Subject: Braidwood Station Unit 1
NRC Docket Number: 50-456

Additional Information Pertaining to Operating Interval Between Eddy Current
Inspections for Circumferential Indications in the Braidwood
Unit 1 Steam Generators

ATTACHMENT B
REQUEST FOR ADDITIONAL INFORMATION
RELATED TO THE BRAIDWOOD, UNIT 1 CYCLE LENGTH ASSESSMENT
BASED ON STEAM GENERATOR (SG) TUBE
CIRCUMFERENTIAL INDICATION GROWTH RATES
DOCKET NUMBER 50-456

Figure 14b: **Probability of Leak vs. Average ECT Amplitude**
(Commonwealth Edison Data)

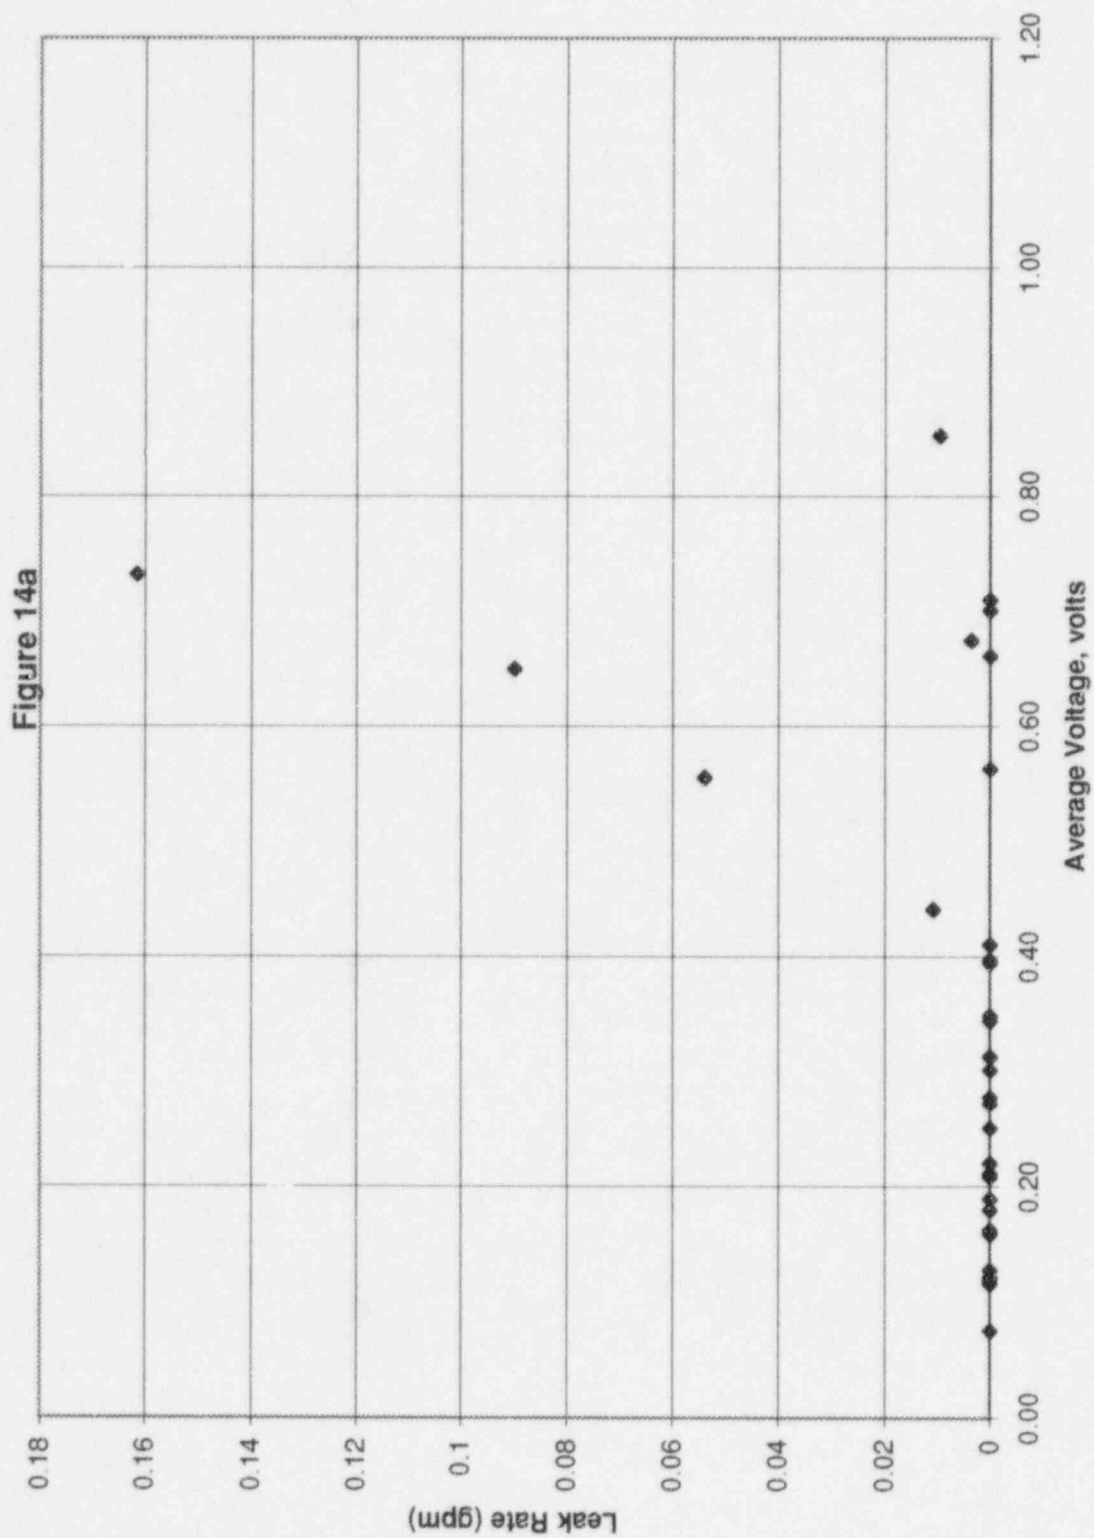
14. The correlation of leak rate versus maximum EC voltage applies only to the end-of-cycle (EDC) EC voltage distributions derived from maximum EC voltages. Provide a similar relationship based on EC voltage integral measurements of circumferential indications. Describe, or reference if previously submitted, the procedure used to normalize the SG tube leak rates to the operating temperature and the main steam line break (MSLB) pressure of 2560 pounds per square inch (psi).

The industry leak rate data from insitu pressure tests and tube pull leak tests is plotted in Figure 14a against average voltage. The average voltage is normalized as discussed in Section 6.2.1 of the Braidwood Cycle Length Assessment Report dated August 2, 1996. A log-logistic probability of leak vs. average ECT amplitude function was developed. The probability of leak function is based upon the data presented in Section 7.0 of the Braidwood Cycle Length Assessment Report dated August 2, 1996. A 95% confidence level of the probability of leak function is used to assess the Braidwood Unit 1 EOC leak rate for the EOC approach for average voltage. Figure 14b shows the function and its lower 95% confidence level. Because a correlation between voltage and leak rate does not exist a maximum leak rate of (0.16 gpm) is assumed for each voltage bin.
